MEMO

Date: March 15, 2021

Re: 110-112 S. Riverview Street, First Review

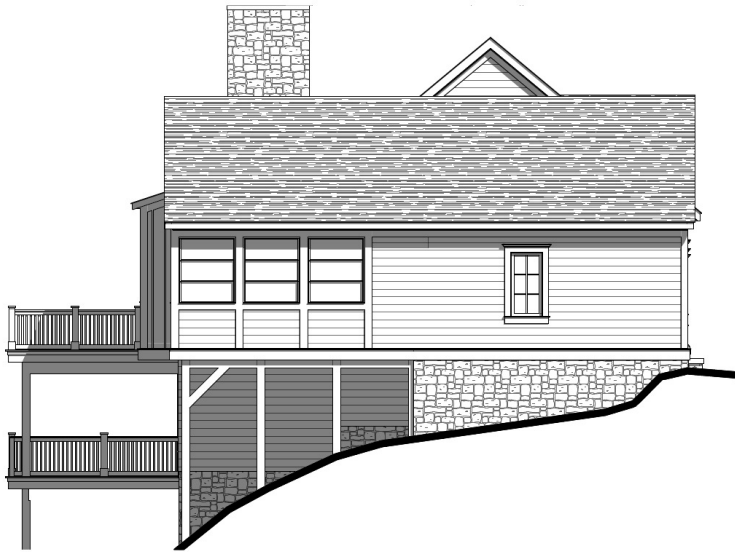
- It is not clear where this structure lies on the site in relation to other neighboring structures (See Figure 2). A site plan which shows neighboring structures would be helpful. Ideally, it should be set back the same distance from the road as neighboring structures.

- Since a rear garage is not possible due to site constraints, the garage should be setback slightly from the main house to lessen its impact from the street. Currently, it is the same distance from the road as the main house.
- Address site issues such as existing landscape features which will be maintained or removed.
- There is a potential for archeological remains on the property. If a potential archeological find is uncovered during the course of demolition and/or new construction, the City of Dublin and the appropriate authorities must be notified immediately.
- The lot immediately to the north of the site and in line with Pinneyhill Lane has a storm sewer outlet. This can create some design challenges for the project and should be addressed in a site plan.
